RESPONSE TO COMMENTS 1.1, 1.2 & 2.3

Project Title
Trinity Islands
Trinity Way
Manchester

Drawing Title
Site D
Site Plan
Ground Floor Plan

FIGURE 2

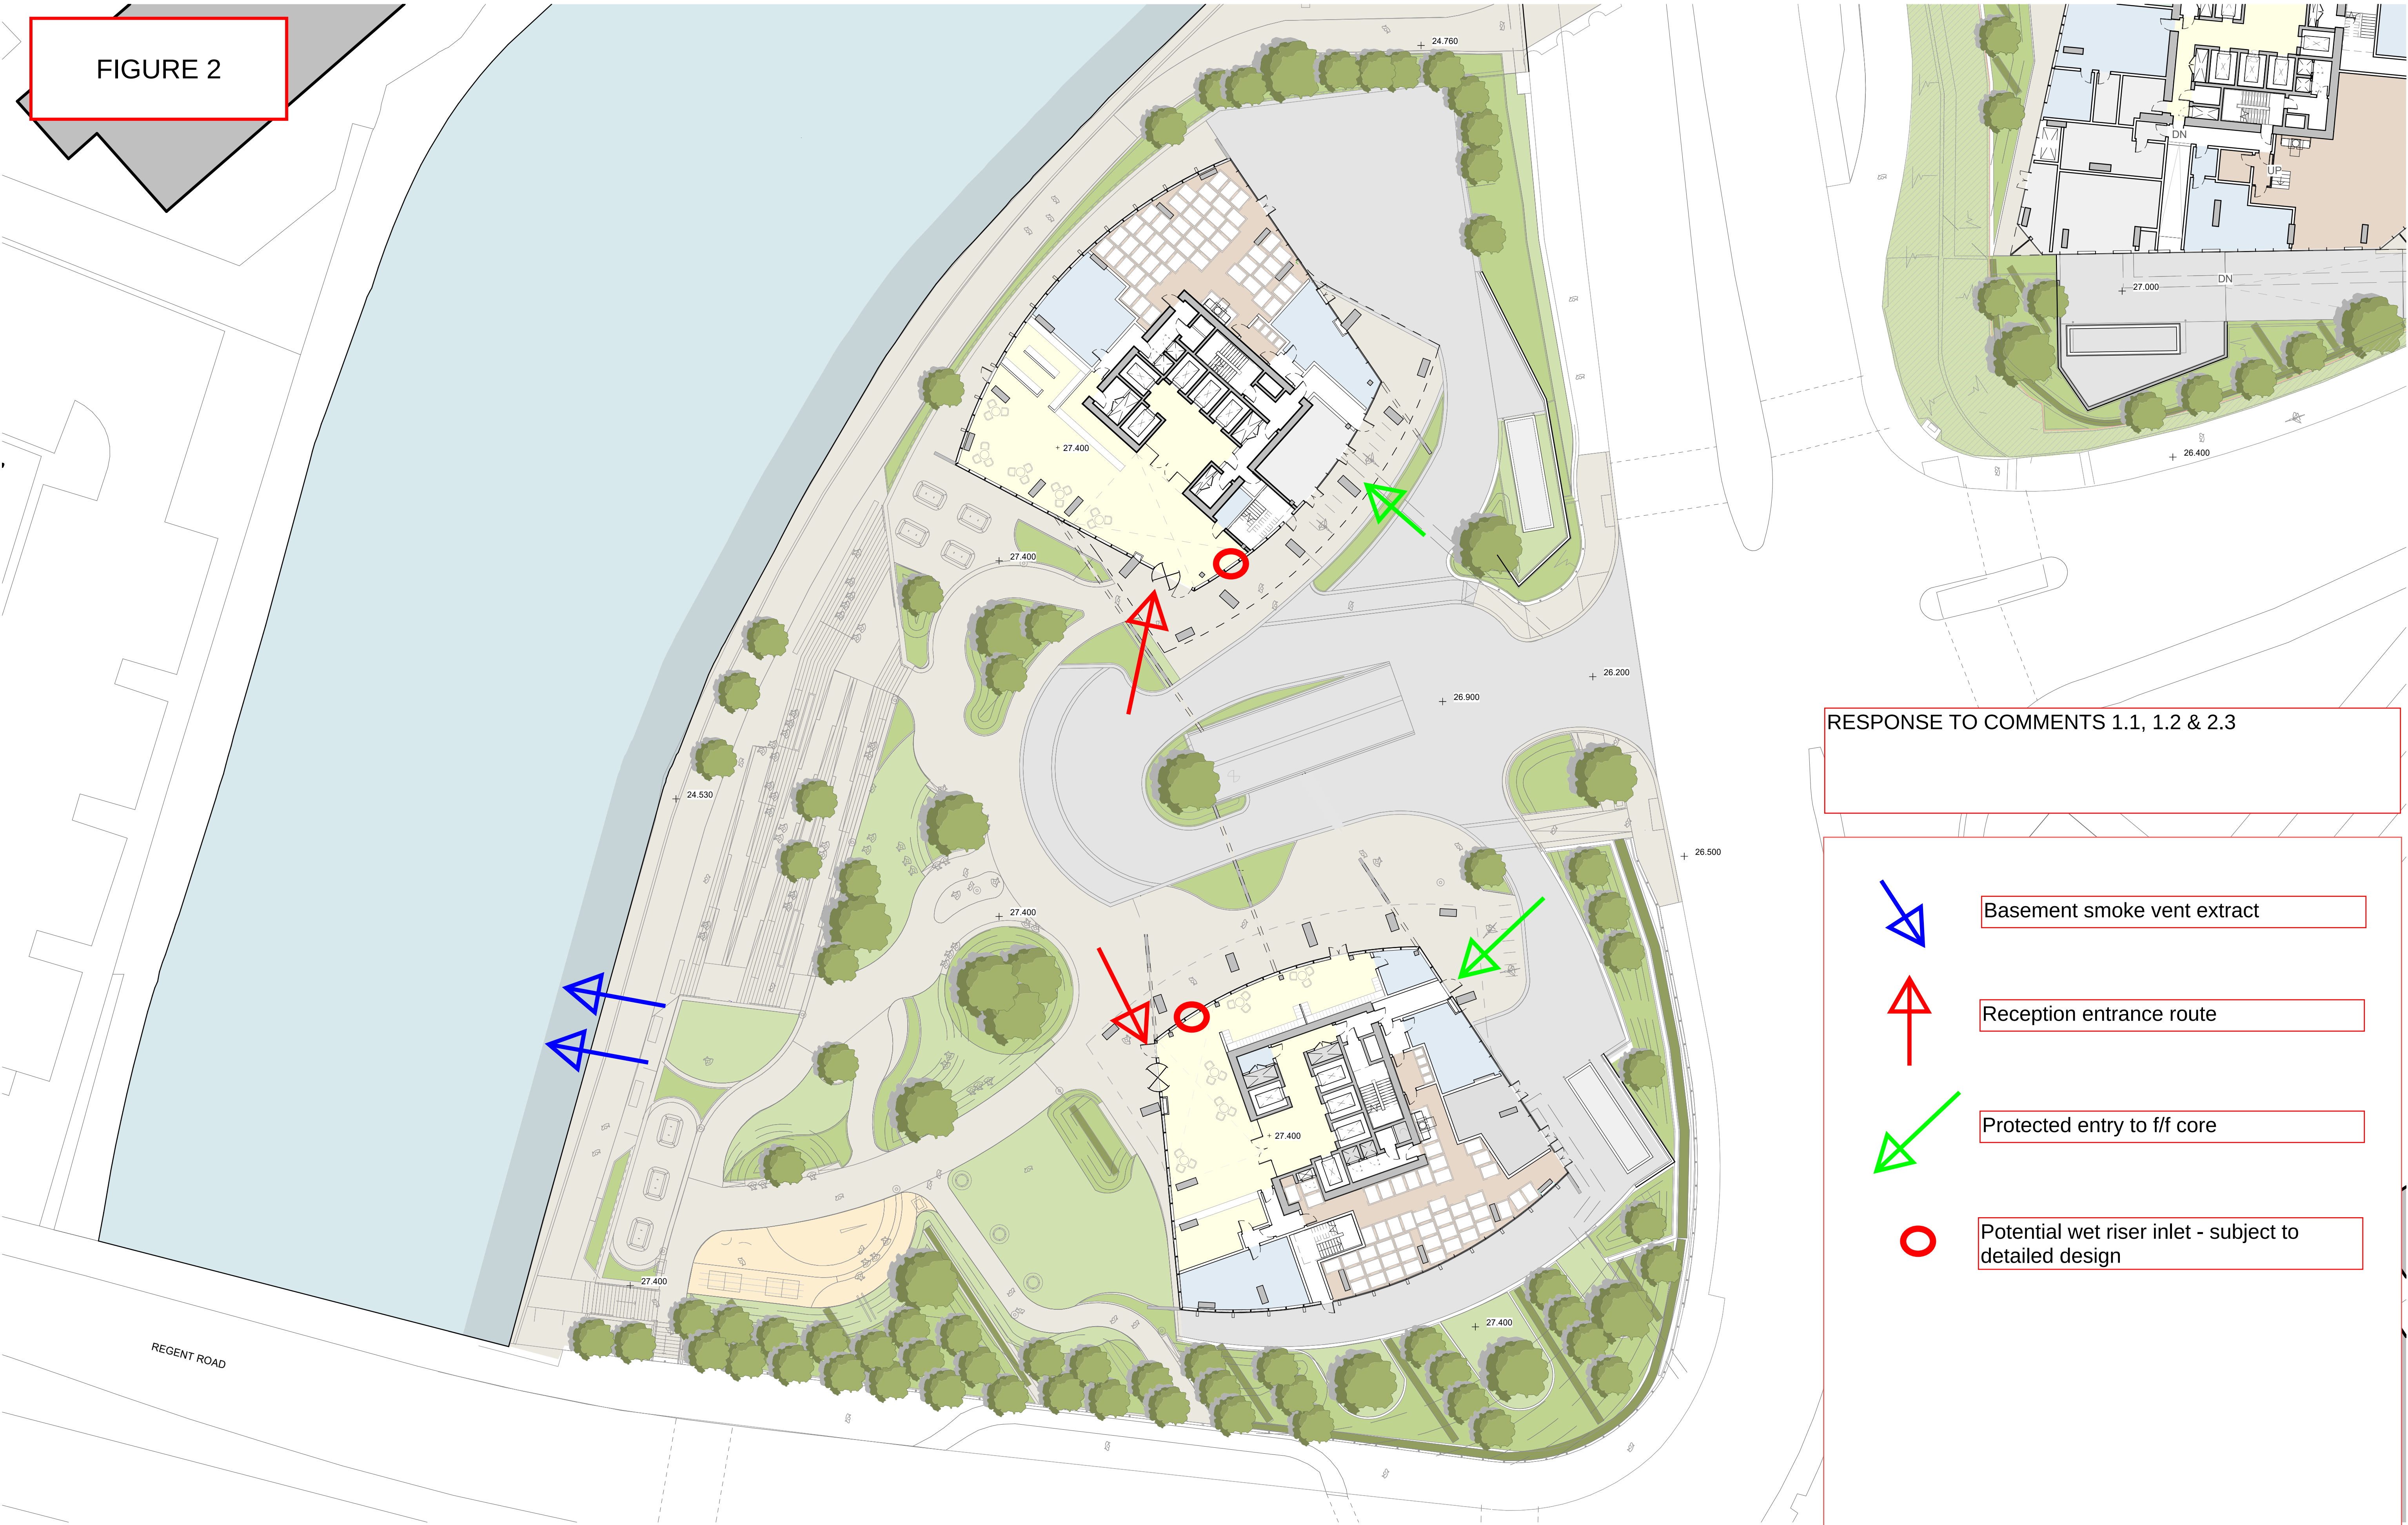
RESPONSE TO COMMENTS 1.1, 1.2 & 2.3

Basement smoke vent extract

Reception entrance route

Protected entry to f/f core

Potential wet riser inlet - subject to detailed design

FIGURE 3

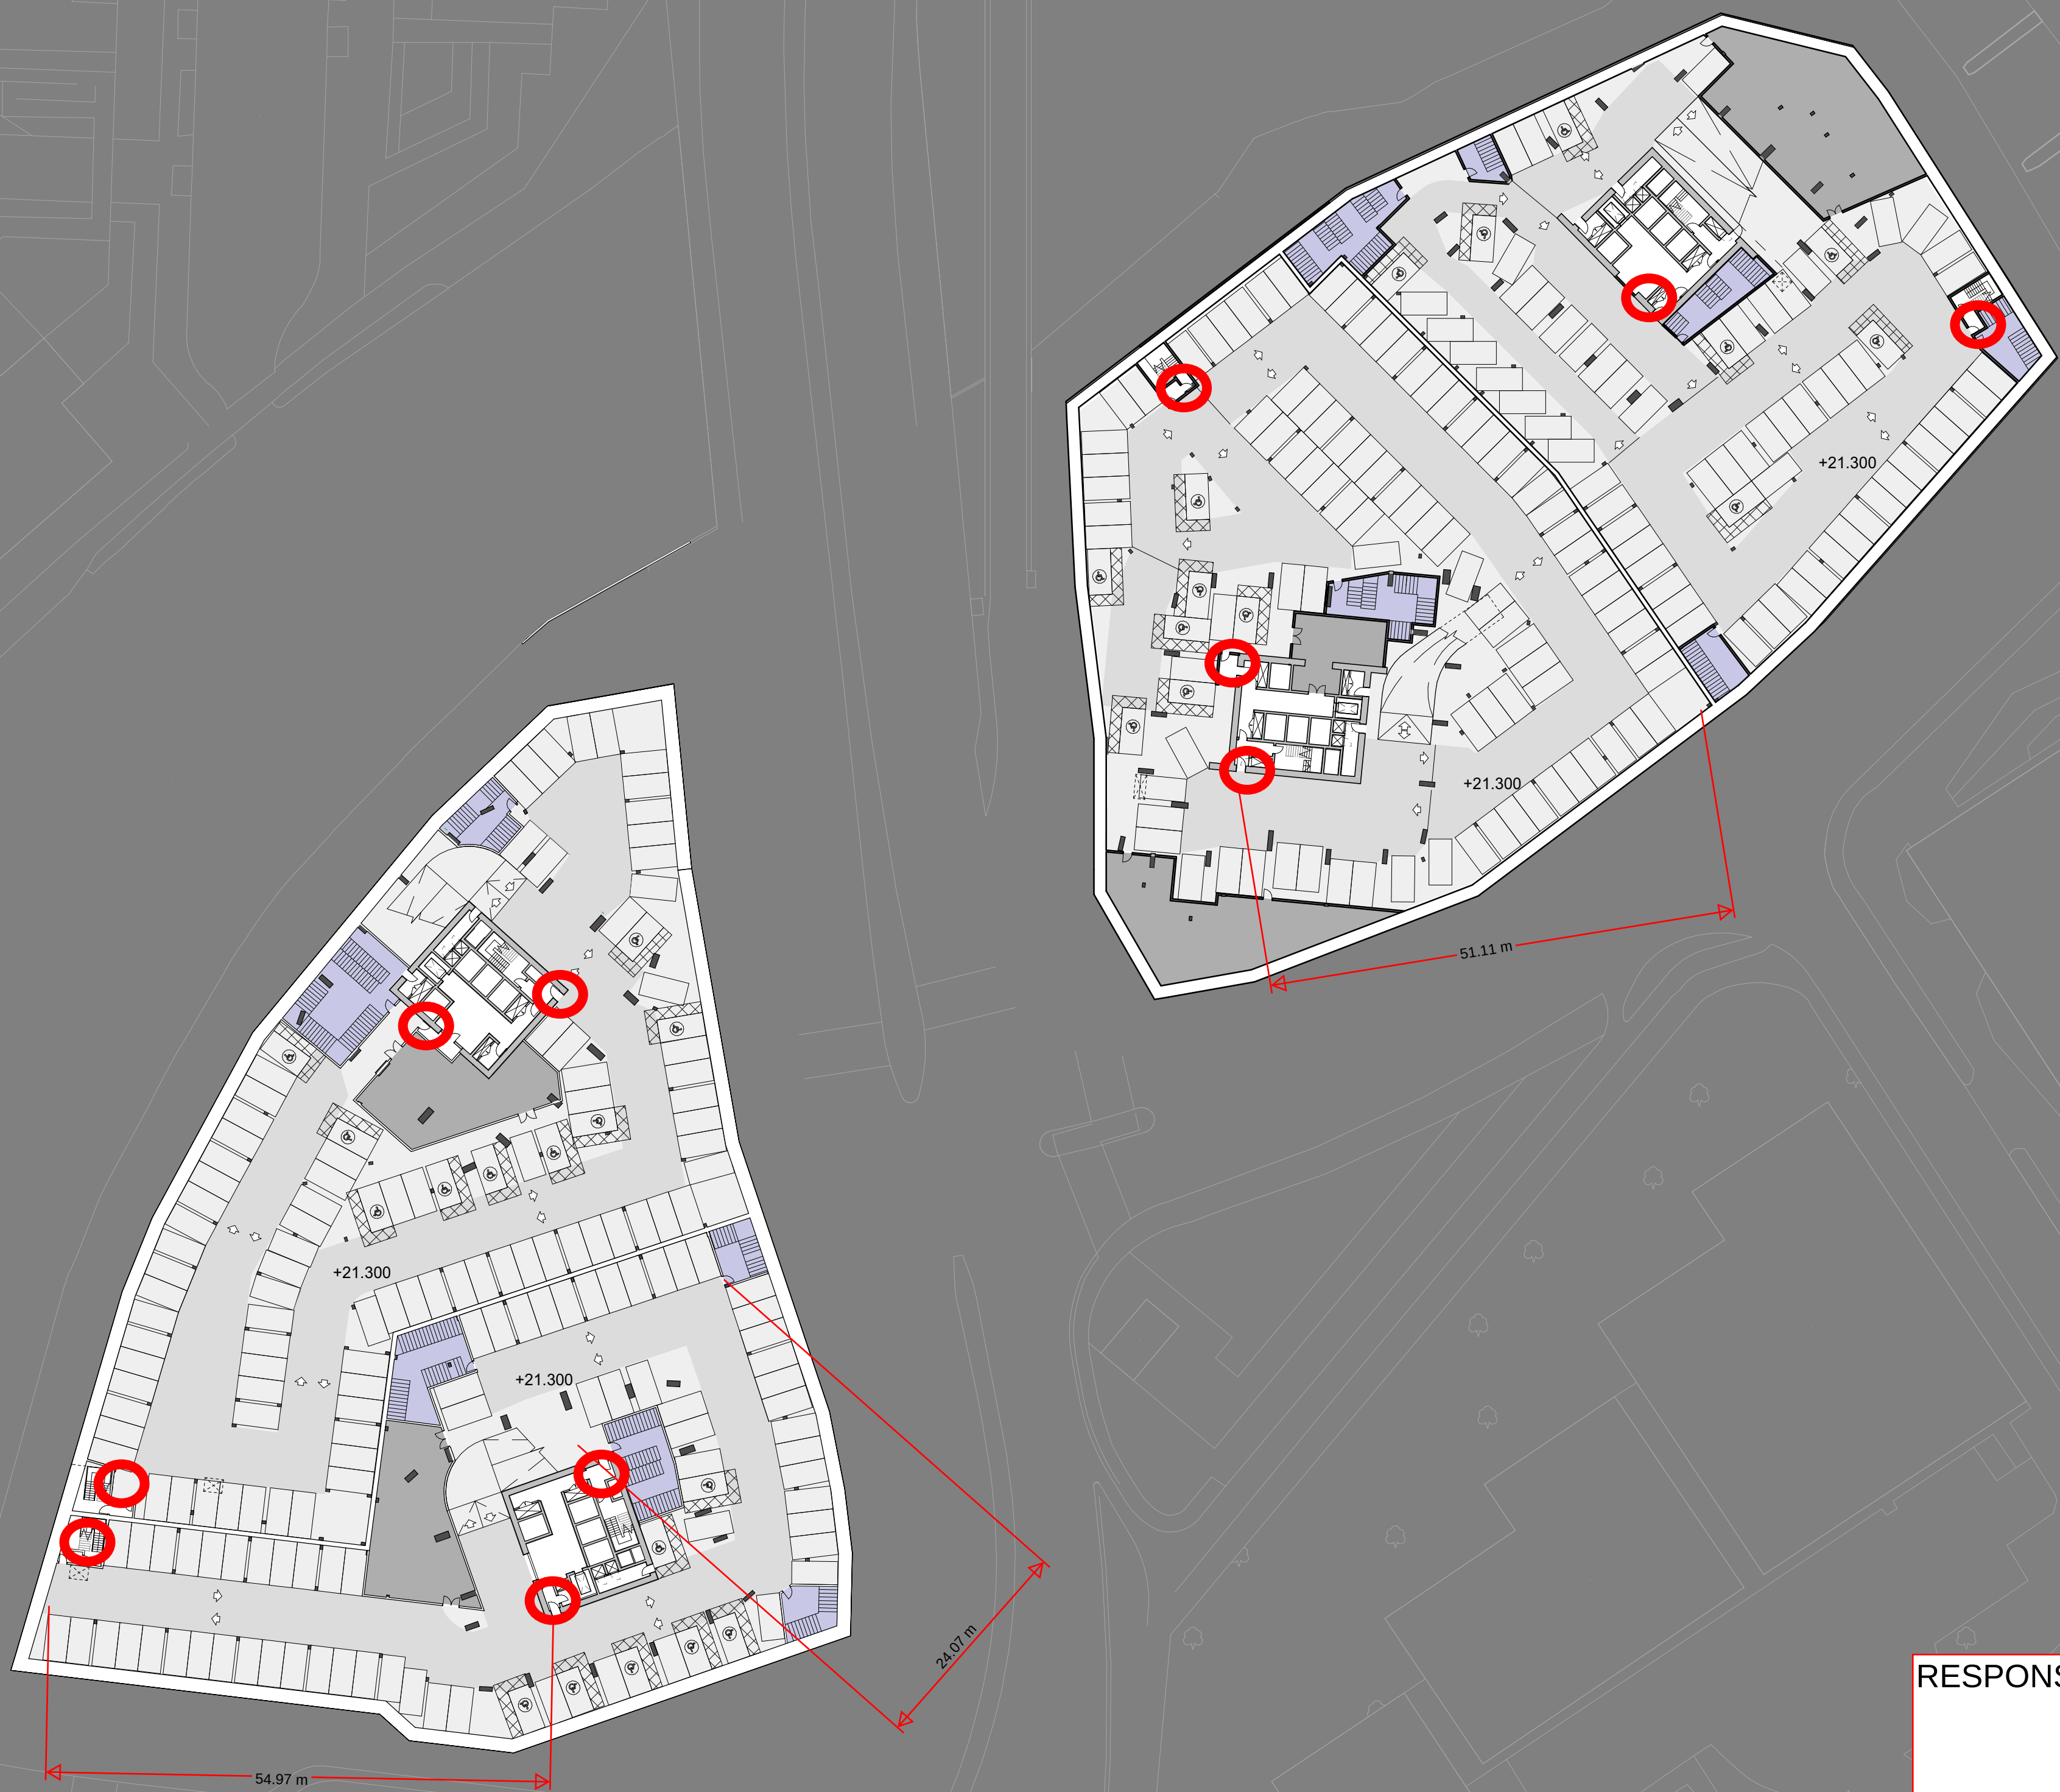
RESPONSE TO COMMENT 2.1

Protected stair entrance locations - multiple points of escape
